<b>Subject:</b> RATTLE AND/OR WIND NOISE FROM FRONT DOOR GLASS AREA	<b>Bulletin No:</b> 09-017/16
	<b>Last Issued:</b> 03/17/2016

2007-2015 CX-9

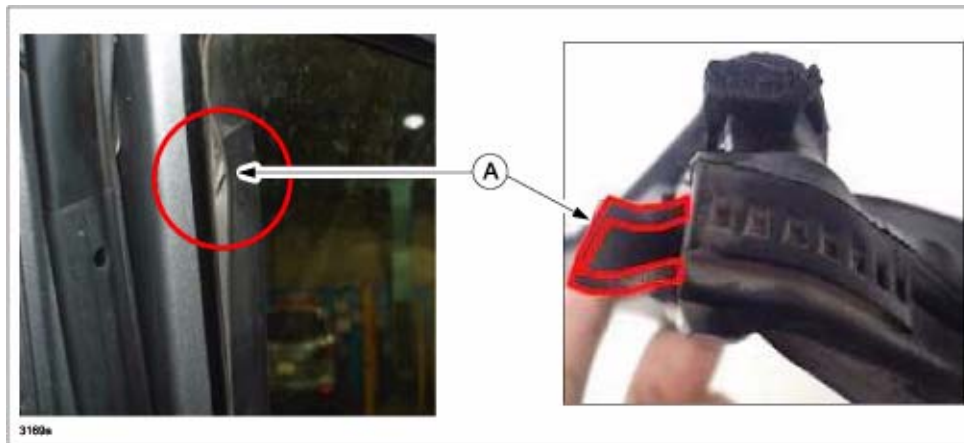
Some vehicles may exhibit a rattle noise and/or wind noise from the front door glass area while driving the vehicle. This is caused by a deformed glass run channel (A). The deformed area is located at the upper rear corner of the run channel and is caused by repeated door glass closures in very hot climates. The deformed area causes poor contact between the glass run channel and the door sash, which results in rattle noise and/or wind noise.
